City Planning Department

Memo

To: Cranston City Plan Commission
From: Doug McLean, AICP, Principal Planner
Date: July 29, 2021
Re: **Dimensional Variances at 70 Plantation Drive
"Garden City Elementary School"**

Owner/App: City of Cranston/Cranston School District
Location: 70 Plantation Drive, AP 10, Lot 709
Zone: A-8 (Residential with at least 8,000 sq.ft.)
FLU: Government/Institutional

3-D SITE MASSING

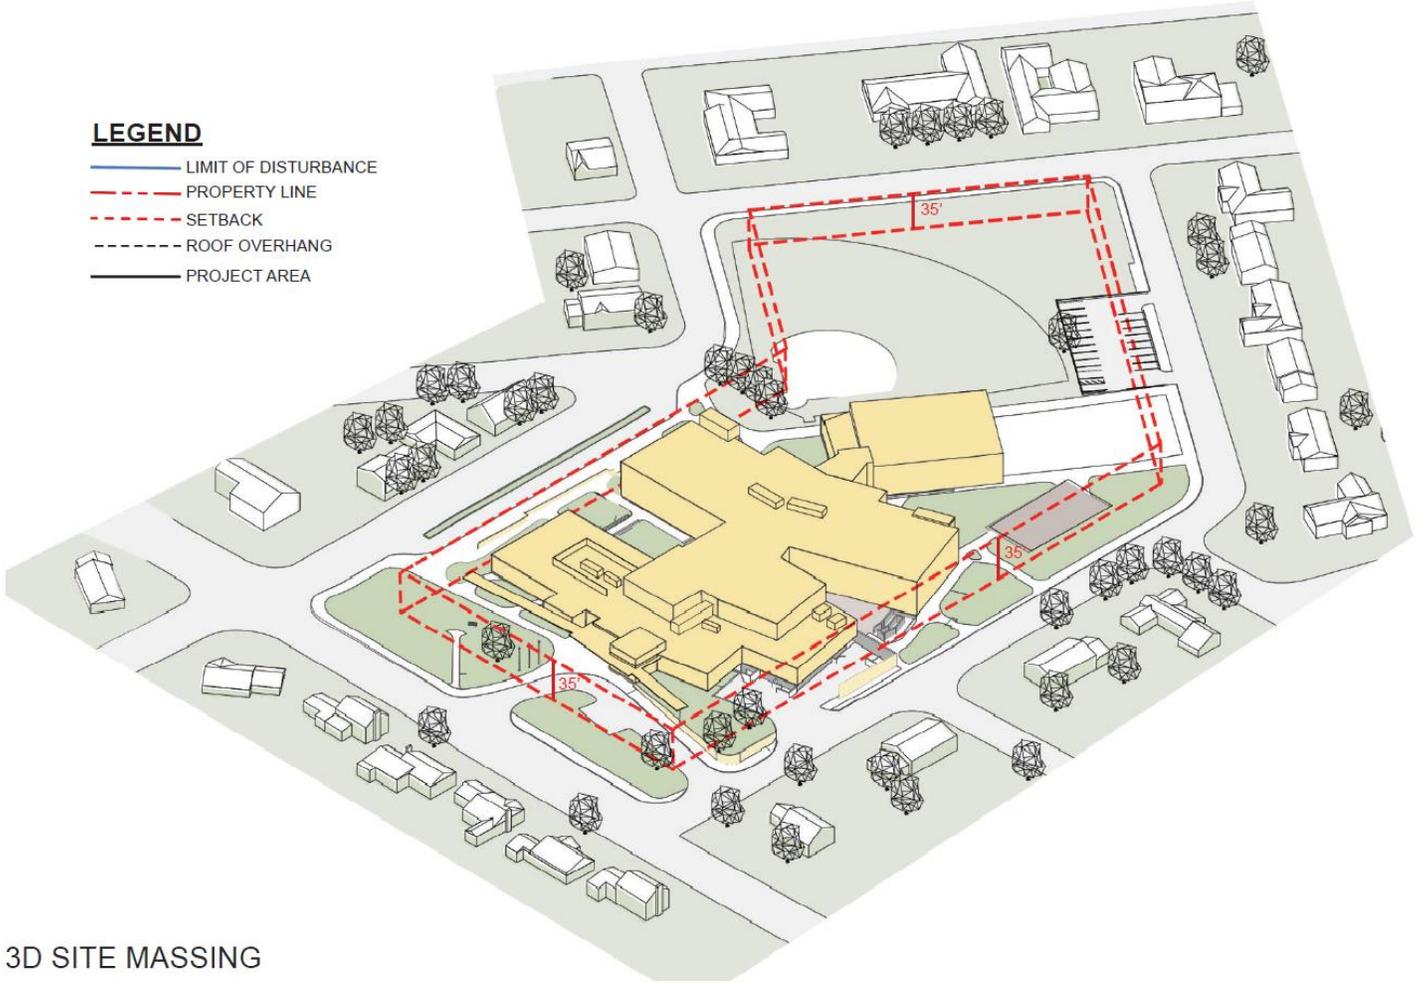
1. There is one small section of the building that exceeds the maximum height requirement of 35 feet as defined by the zoning code. In the north east corner of the building, a single stairway extends above the roof for maintenance access purposes. In this one case, the height is forty feet 40'-0" above grade. Please see the diagram below for additional visual context the stairway (labeled "NE Stair Tower")

2. At the NE Stair Tower location of the building (where the height exceeds the zoning maximum), the structure is sixty feet from the property line (40 ft more than the required 20 ft yard setback) and is only an additional five feet of height to be over 35 feet. Additionally, it is located towards the center of the property along Magazine Street.

3. The stair enclosure is not near any adjacent properties, and only faces an adjacent baseball field, therefore we do not see that this is creating any harm to nearby residences.
4. The relief for the height will also greatly benefit the functionality of the building as the stair is also the primary roof access for maintenance and provides a safe path for maintenance staff.
